**適航指令發布單**  
**Airworthiness Directive Issuance Form**

# EMERGENCY AIRWORTHINESS DIRECTIVE

**Number: G-2021-0010-E**

## ATA 28 – Fuel –Cylinder Quick Shut-off Valve Mounting Flange – Inspection / Replacement

Figure 1: *CB437 Flanged Adaptors for Quick Shut-Off (QSO) valves*

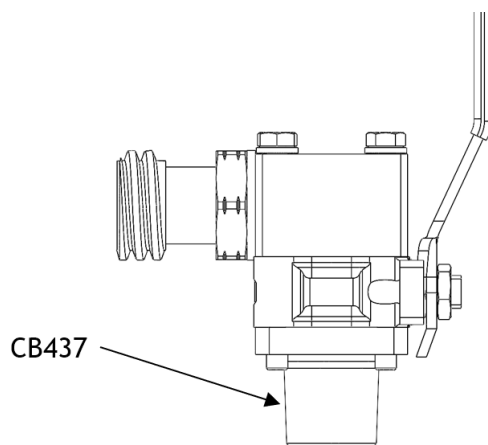
Certain Cameron Hot Air Balloon fuel cylinders are supplied with liquid offtakes that consist of a quarter turn ball valve mounted on a flanged adaptor (P/N CB437, see figure 1). Two recent batches of these adaptors have been manufactured with non-conforming (undersize) threads.

In certain cases, when the minimum sized adaptors are combined with cylinder bosses at maximum tolerance dimension and assembled to fuel cylinders, the thread can impinge (“bottom out”) on the cylinder boss. Although the required tightening torque value can be achieved at installation, the torque required to unscrew the flange could be below the minimum value. In extreme cases the adaptor may be unscrewed by hand.

4. From the effective date of this AD, do not install an affected part on any cylinder.
5. Within 4 months after the effective date of this AD, modify each cylinder by replacing the P/N CB437 issue F QSO flanged Adaptor, with a P/N CB437 issue G (or later issue) QSO flanged adaptor in accordance with the instructions of the SB, or by replacing the QSO valve assembly with a handwheel valve part No CB0824-0001 (this part has a Rego-type hose connection).
